# Access Compliance Report

## Public Rights-of-Way

### (Curb Ramps)

Intersection ID: N/A	Main Street: ARDREY_KELL_RD	Cross Street: WAVERLY_WALK_AV	Location: NW
ADA ID: 7842E408D251	Ramp Type: Directional1	Initial Pass/Fail: Fail	Overall Compliance: No
		Severity Score: 1.25

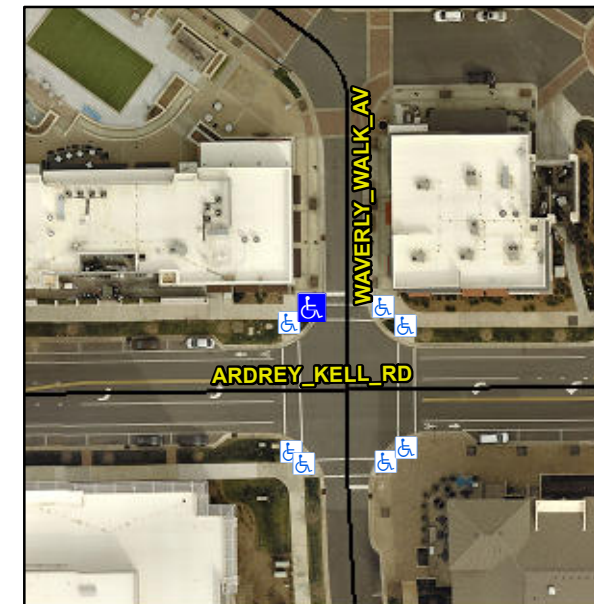
**R304.5.3**

Compliance	Description	Data	Compliance	Description	Data
N/A	Ramp Length (in)	85.0	N/A	Grade Break?	N/A
Yes	Ramp Width (in)	89.0	N/A	Grade Break Slope (%)	0.0
Yes	Ramp Slope (%)	6.9	N/A	Grade Break XSlope (%)	0.0
No	Ramp XSlope (%)	2.5			
N/A	Flare Type LT	N/A	N/A	Flare Type RT	N/A
N/A	Flare Slope LT (%)	N/A	N/A	Flare Slope RT (%)	0.0
N/A	Flare Traversable LT?	N/A	N/A	Flare Traversable RT?	N/A
N/A	Landing Length (in)	0.0	N/A	DWS Provided?	N/A
N/A	Landing Width (in)	0.0	N/A	DWS Contrast?	N/A
N/A	Landing Slope (%)	0.0	N/A	DWS Length (in)	N/A
N/A	Landing X Slope (%)	0.0	N/A	DWS Full Width?	N/A
N/A	Landing Curb? (Y/N)	N/A	N/A	DWS Offset LT (in)	N/A
N/A	Shared Landing?	N/A	N/A	DWS Offset RT (in)	N/A
N/A	Gutter Ponding?	0.0	N/A	Gutter Slope (%)	N/A
N/A	Gutter Lip Ht (in)	0.0	N/A	Gutter X Slope (%)	N/A
N/A	Painted X Walk1?	Yes		Road Slope (%)	0.6
	X Walk 1 Direction	To E		Road X Slope (%)	0.8
	X Walk 1 Width (in)	103.0		Clear Space?	N/A

**Remove & Replace Entire Ramp.**
